Re: **Joliet Junior College, Illinois Community College District No. 525
Master Facilities Plan Phase 1, Campus Center Building Work, Bid Release 12
1215 Houbolt Road, Joliet, Illinois 60431**

Subject: **Supplement No. 2**

LEGATARCHITECTS WAUKEGAN OAK BROOK CHICAGO CRYSTAL LAKE 651 W. WASHINGTON BLVD. - SUITE 1 CHICAGO, ILLINOIS 60661 PHONE: (312) 258-9595 FAX: (312) 258-1555	Joliet Junior College Campus Center	PROJECT NUMBER: 208069	SKETCH ASK-27
	Partial Level 2 - Module 2 Reflected Ceiling Plan	DATE: 01/07/10 REF: Reference: 1/A7.22

Enlarged Reflected Ceiling Plan - Dining Skylight

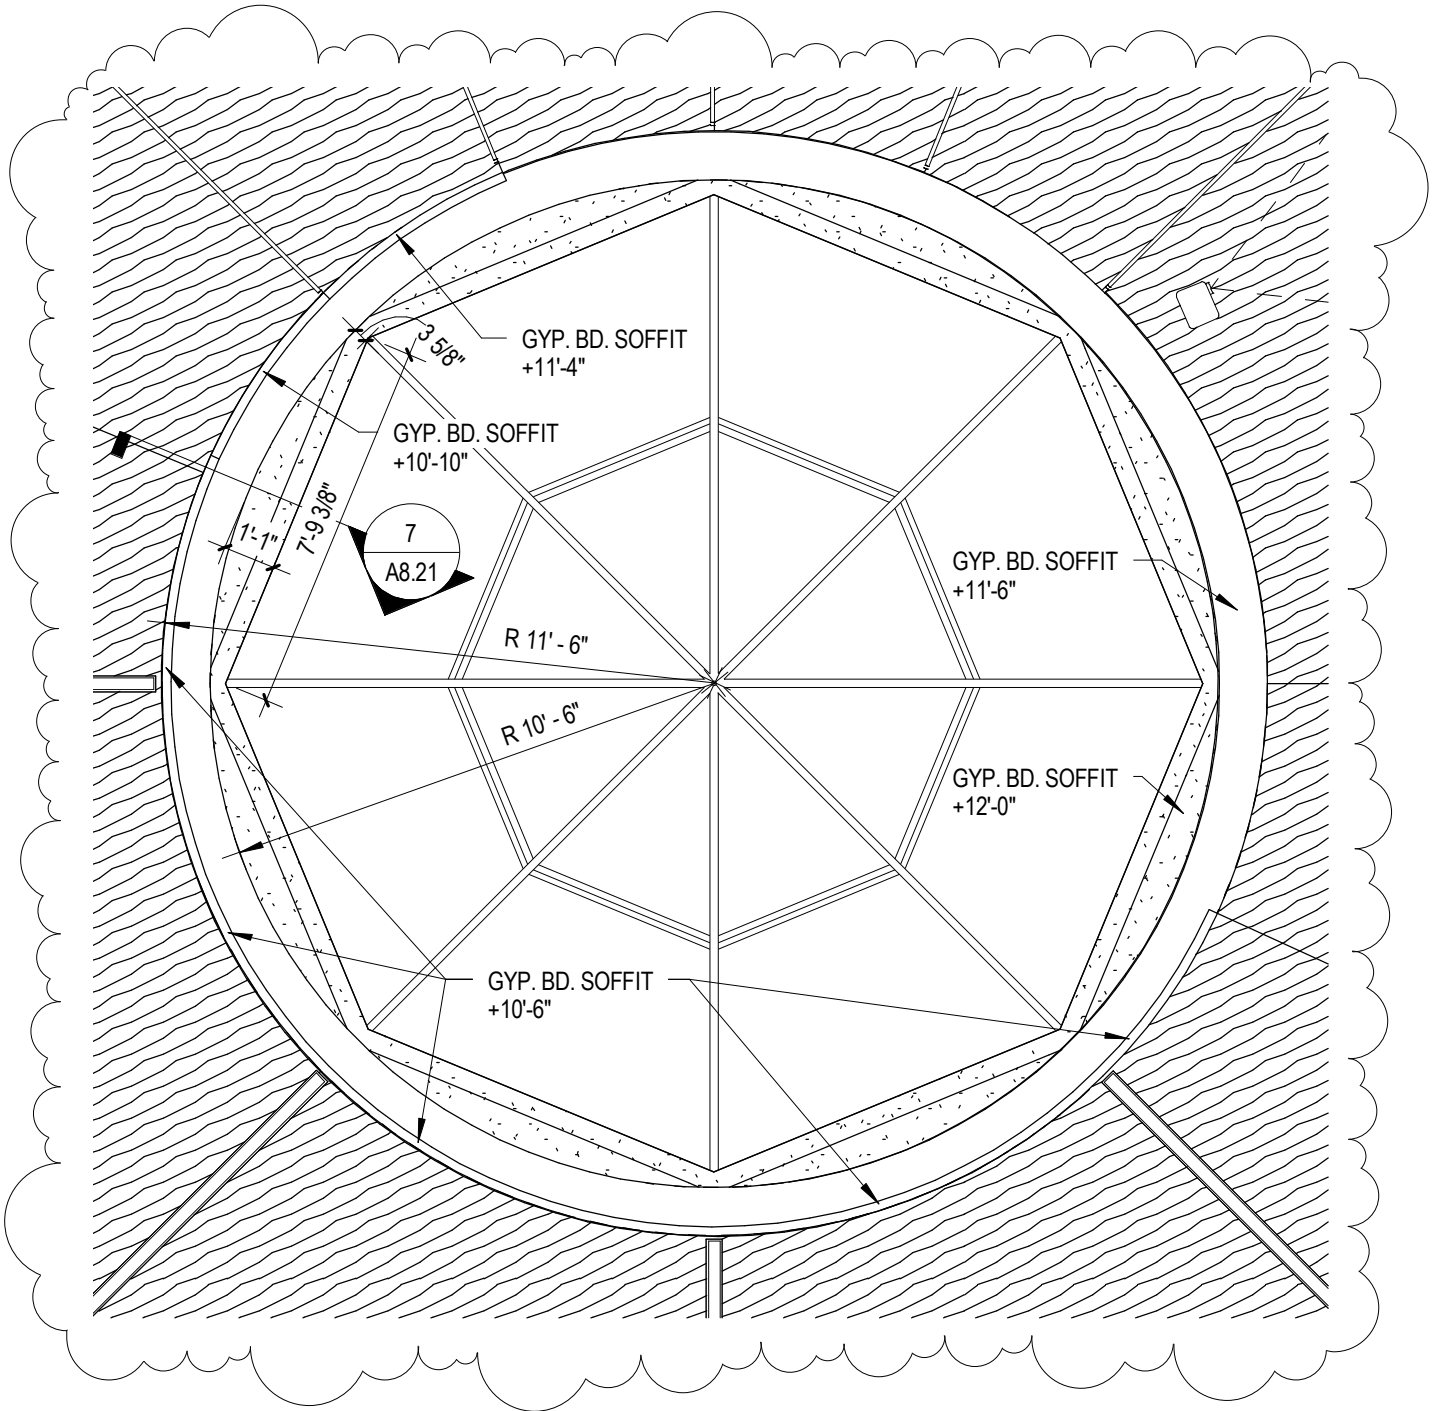
- cc) Drawing A7.22: REVISE the ceiling plans as shown on attached sketch ASK-38.
- dd) Drawing A7.40:
 i) REVISE Keynote 05500.U2 to read, "Stainless Steel Suspension System."
 ii) ADD the following note:
 "Stainless Steel Suspension System: Basis of design is Sadev Architectural Glass Systems. Components include Model #08-81-80-06-24-20 shelf fixing plate, with Model #08-85-80 tie rods, and

Dining Room Skylight Detail

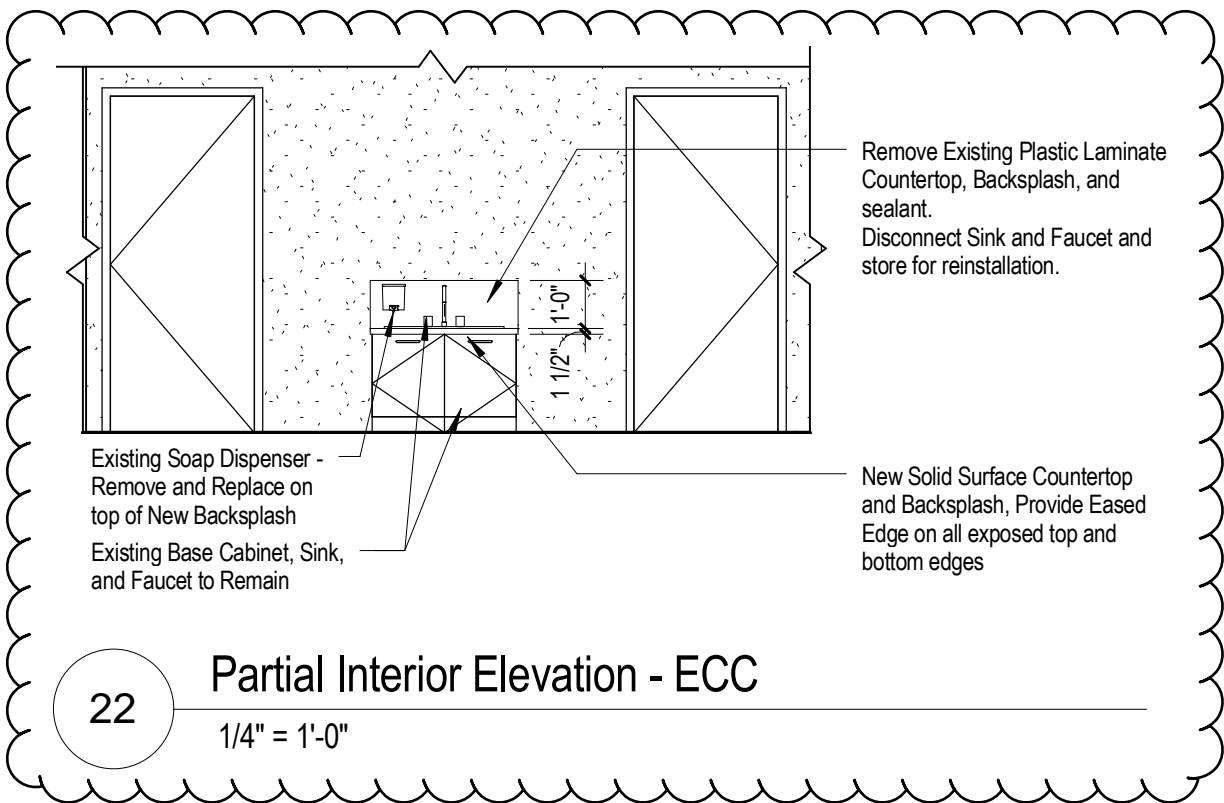
12. At all wood ceilings, provide wood trim at vertical transitions between different levels. Coordinate with locations where diffusers or lighting are called for. Refer to Mechanical and Electrical plans."
 ii) REVISE Reflected Ceiling Plan Note 4 to read, "4. Ceiling elevations noted are above finished floor, EXCEPT on A7.11 given elevations are above +0'-0" floor level."
 iii) ADD detail 4 as shown on attached sketch ASK-38.

LEGATARCHITECTS WAUKEGAN OAK BROOK CHICAGO CRYSTAL LAKE 651 W. WASHINGTON BLVD. - SUITE 1 CHICAGO, ILLINOIS 60661 PHONE: (312) 258-9595 FAX: (312) 258-1555	Joliet Junior College Campus Center		SKETCH ASK-32
	3046 North Interior Elevation	PROJECT NUMBER: 208069 DATE: 01/07/10 Reference: 21/A6.32

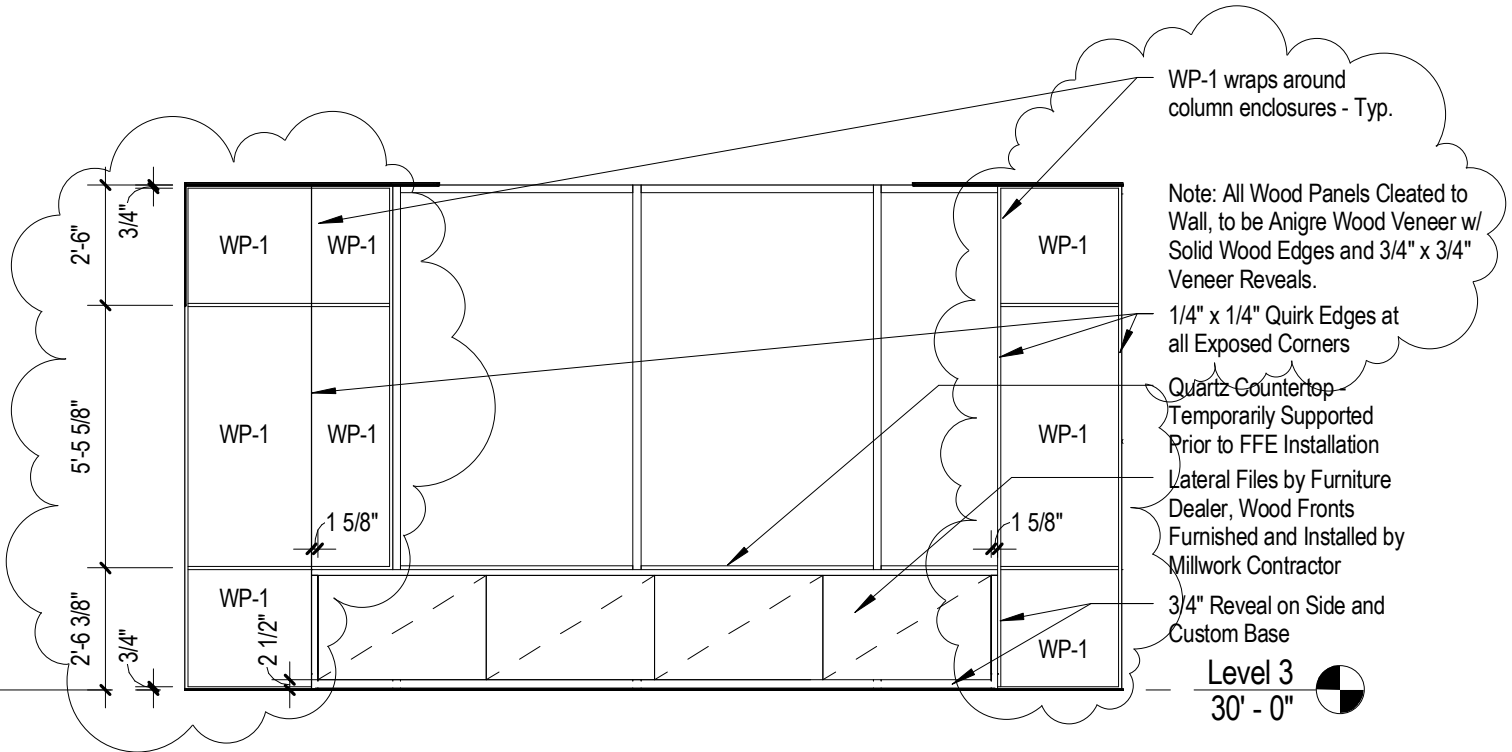
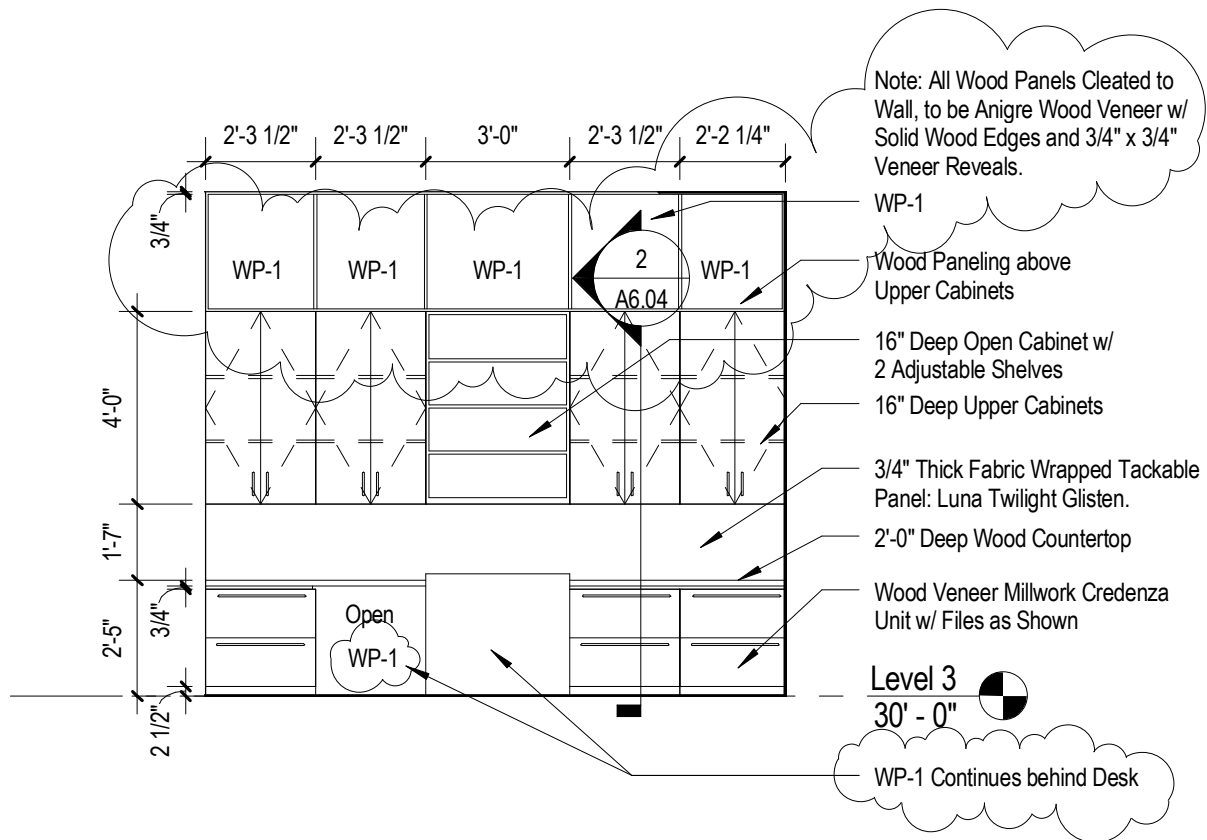
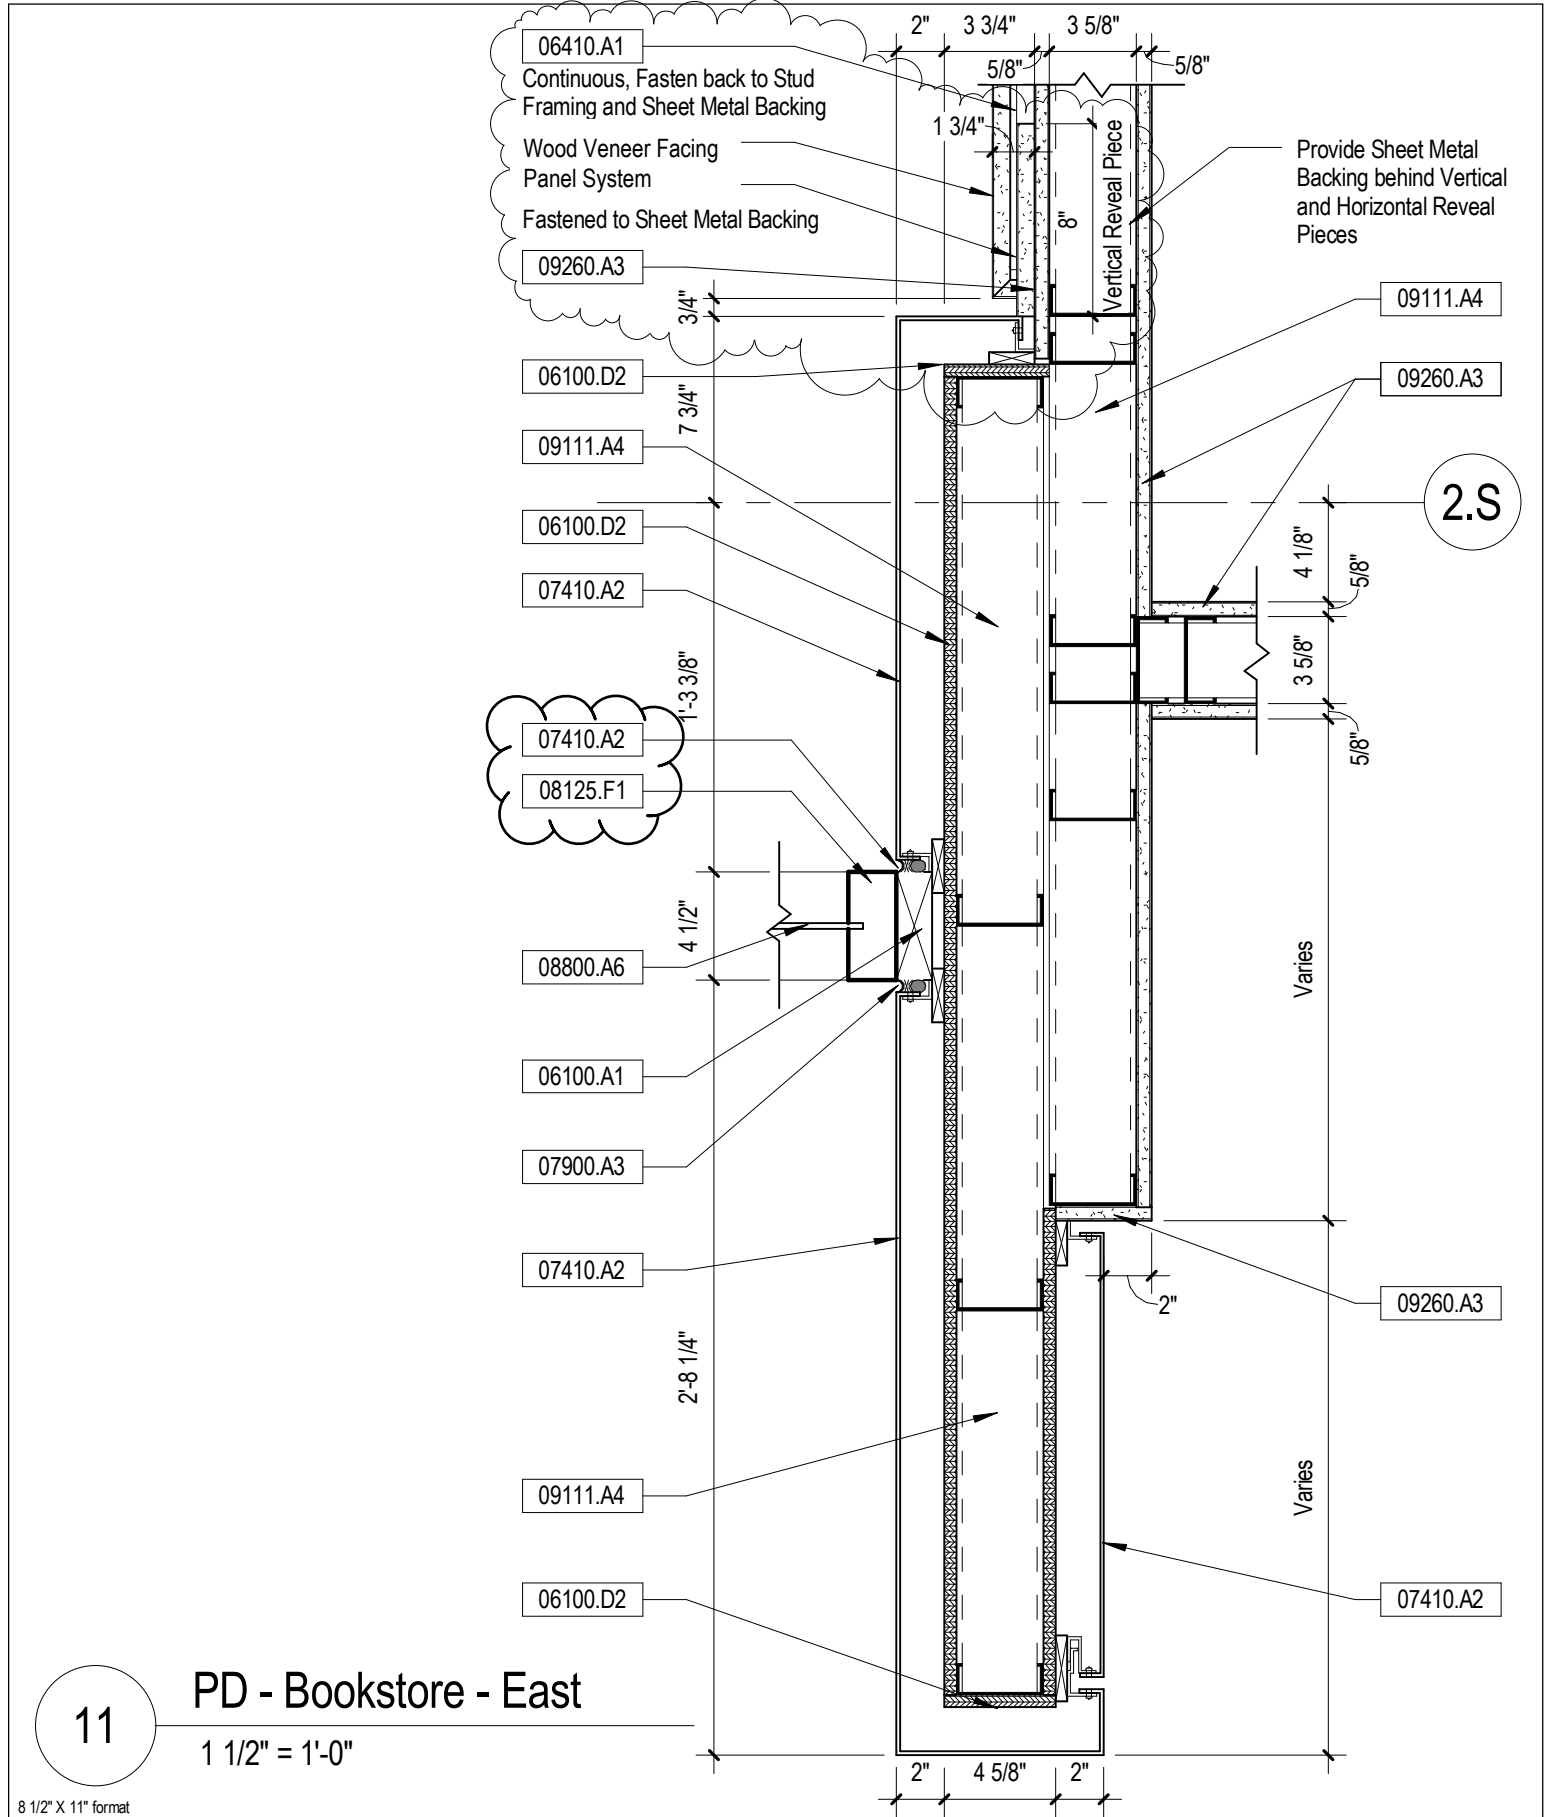
- z) Drawing A6.32: REVISE details 21, 22, and 23 as shown on attached sketches ASK-32, 33, and 34 respectively.
- aa) Drawing A7.11:
 i) ADD Reflected Ceiling Plan Notes as follows:
 "10. ACT and Gyp. Bd. ceilings and soffits are continuous above suspended glass ceilings, EXCEPT at Dining 1000 and Servery 1003. Coordinate holes for glass ceiling suspension rods.

LEGATARCHITECTS WAUKEGAN OAK BROOK CHICAGO CRYSTAL LAKE 651 W. WASHINGTON BLVD. - SUITE 1 CHICAGO, ILLINOIS 60661 PHONE: (312) 258-9595 FAX: (312) 258-1555	Joliet Junior College Campus Center	PROJECT NUMBER: 208069	SKETCH ASK-35
	Plan Detail	DATE: 01/07/10 Reference: 11/A3.02

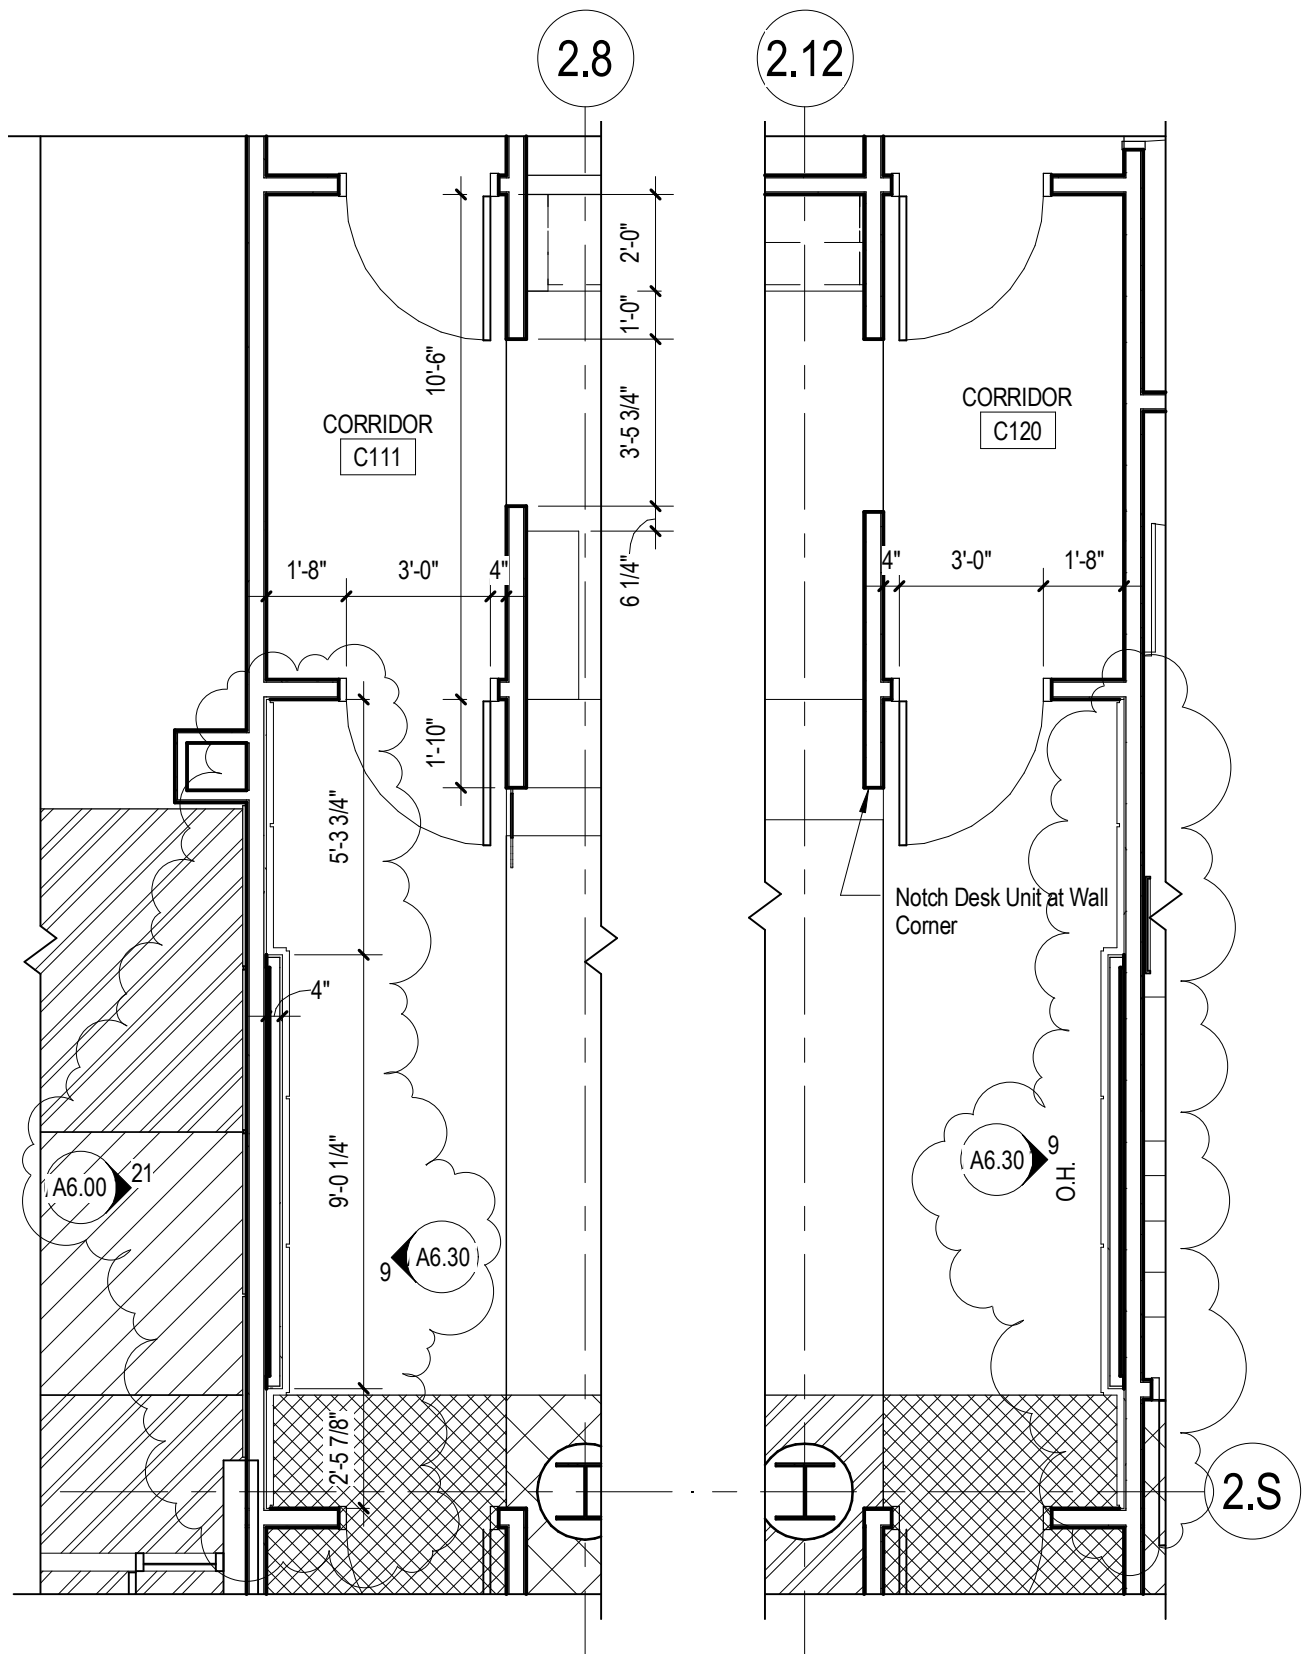
- j) Drawing A3.02:
 i) REVISE detail 11 as shown on attached sketch ASK-35.
 ii) REVISE Keynote “06423” to read, “Fabricated Acoustic Wood Panels.”
 iii) REVISE Keynote “08410.B1” to read, “08125.B1.” Replace this keynote in all applicable details on this sheet.
 iv) REVISE Keynote “08410.F1 – Aluminum Framed Glazing System” to read, “08125.F1 – Interior Aluminum Framed Glazing System.” Replace this keynote in all applicable details on this sheet.
